# UNITED STATES PATENT AND TRADEMARK OFFICE

This is the **Final Office Action** for application number 10/624,152 Modular Accessory Holder, filed on 7/21/03. Claims 1-3 are pending. This **Final Office Action** is in response to applicant's reply dated 7/28/05. The text of those sections of Title 35, U.S. Code not included in this action can be found in a prior Office action.

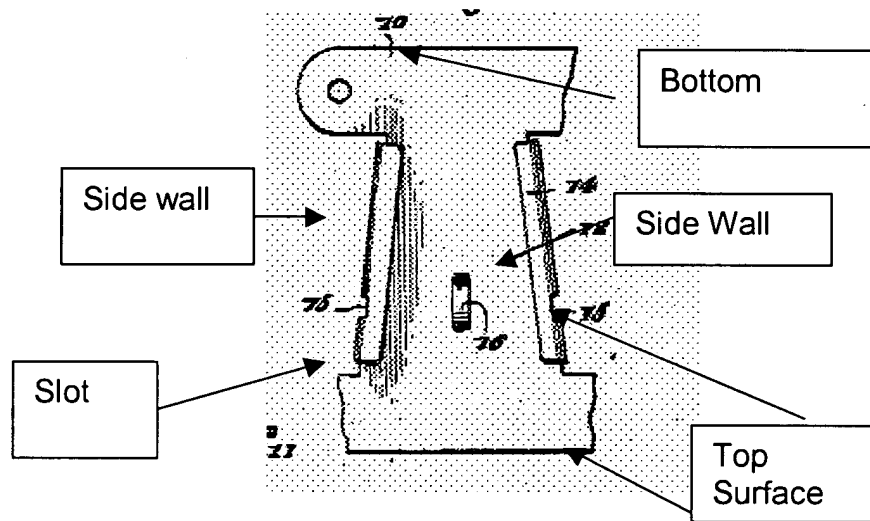
Claims 1 and 2 are rejected under 35 U.S.C. 102(b) as being anticipated by United States Patent No. 2174140 to Schofield.

The patent to Schofield discloses a device having a receiver (10) fixedly attached to a fixed point, wherein the receiver has a top surface (See Drawing Below), and an open front, a slot opening in the top surface and descending downward therefrom having an upper portion and a lower portion, wherein the slot is bounded by a back wall (12), a front wall (14), and first and second side walls (See Drawing) which taper toward each other so that the upper portion is wider than the lower portion of the slot.

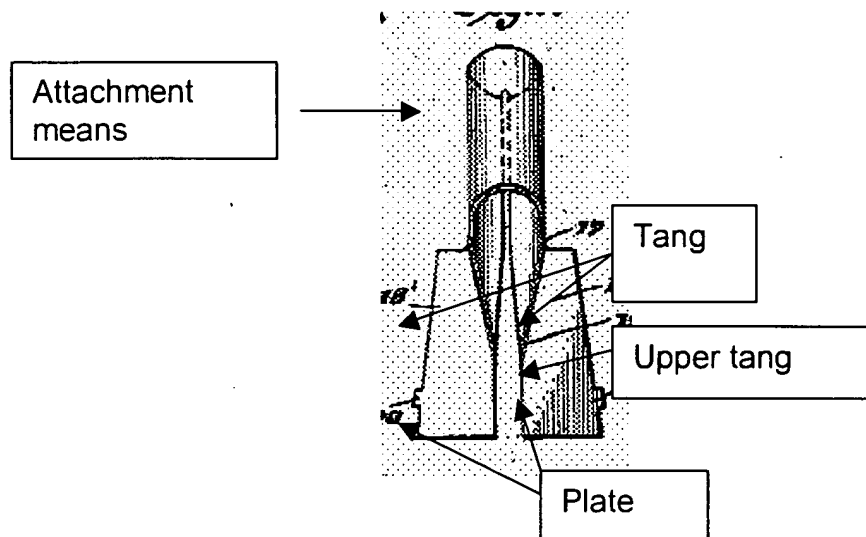
Schofield also discloses a modular mount (17, 18', 19, 20) including an attachment means (See Drawing Below), a plate (See Drawing), a tang (See Drawing) having a back wall, a front wall, a first and second side wall, wherein the first and second sidewalls are parallel to the first and second side walls of the slot respectively when inserted in the slot, the tang descending from the plate first and second steps (20) proximate to a junction between the tang and the plate, wherein the first and second steps are positioned to bear against a top surface while maintaining a small clearance between the first and second side walls, wherein the first and second side walls of the

tang taper toward each other so that the upper portion of the tang is wider than the lower portion and wherein the weight of the modular mount will tend to retain the tang in the slot.

The applicant has argued Schofield does not teach a device in which the steps bear against the top surface. This is unpersuasive in that the top surface as defined above include a surface in which the steps bear against. The applicant has also argued that that the weight of the device does not help to aid the tang to retain the tang in the slot, due to the wedge's orientation. This is unpersuasive because the limitation is being argued narrower than claimed and the weight of the tang will aid the steps to bear against the top surface of the device as shown above.
